STAFF REPORT SAN CLEMENTE PLANNING COMMISSION

SUBJECT: Development Permit (DP) 23-416, Bauder Addition, 106 W Paseo de

<u>Cristobal</u>, a request for a 603 square-foot second story addition and 180 square-foot balcony addition to an existing single-family residence located at 106 W Paseo de Cristobal within the Residential Low Zone and Coastal Zone Overlay District (RL-CZ) adjacent to a historic structure located to the northeast of the subject property and to determine whether the project is Categorically Exempt from the California Environmental Quality Act (CEQA) pursuant to State CEQA Guidelines 14 CCR §15301, Class 1:

SITE PLAN (PROPOSED)

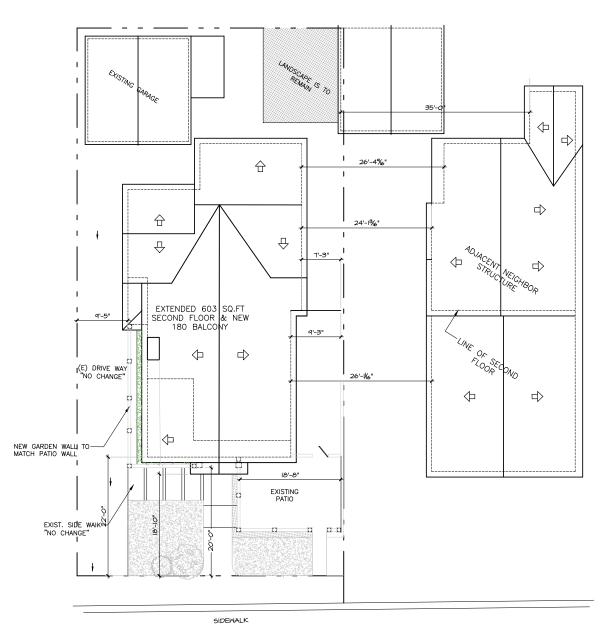
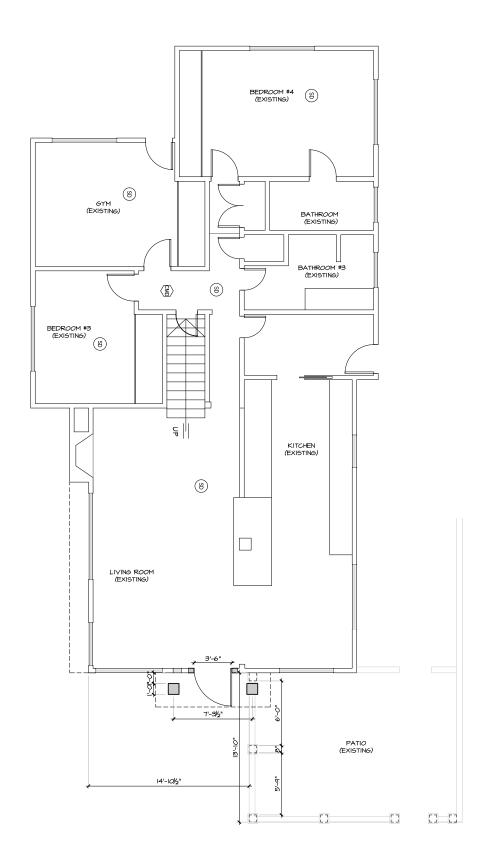
- Clarified with the applicant that the height of the proposed 2nd floor addition is shorter than the 2nd story element on the adjacent historic structure.
- The front setback dimension of 22' on the site plan does not indicate the shortest distance from the front property line to the proposed columns on the

front elevation. Indicated that the site plan should note the shortest proposed front yard setback. In response, the project designer indicated that the columns meet the 20' front yard setback requirement.

FRONT ELEVATION (PROPOSED)

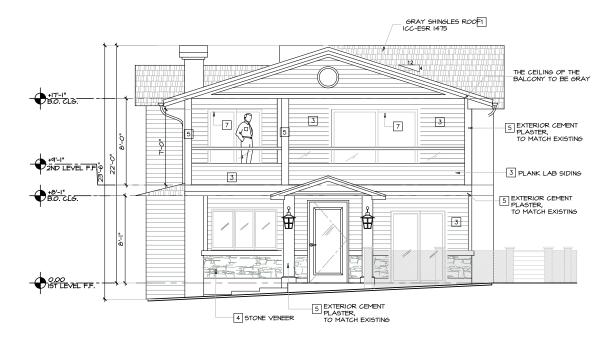
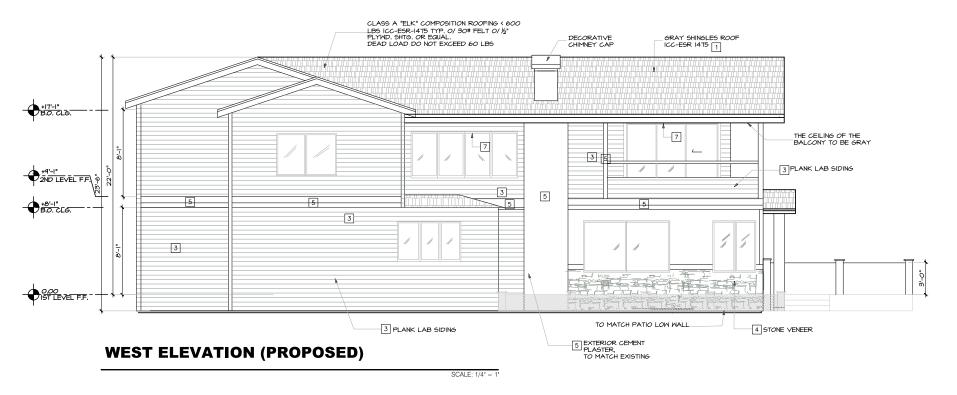
- The project is approvable as proposed, and added the following comments for the applicant's consideration:
 - Simplify the project design by minimizing the amount of white trim on the elevations
 - o Concurred with staff's comment to incorporate the gray siding throughout all four sides of the building
 - Consider raising the ceiling of the 2nd story addition and make it a darker color to reduce the weight of the front gable end on the front elevation

THE FRAMES OF THE NEW WINDOWS AND DOORS WILL MINIMIZING THE AMOUNT OF WHITE TRIM IN THE ELEVATIONS .
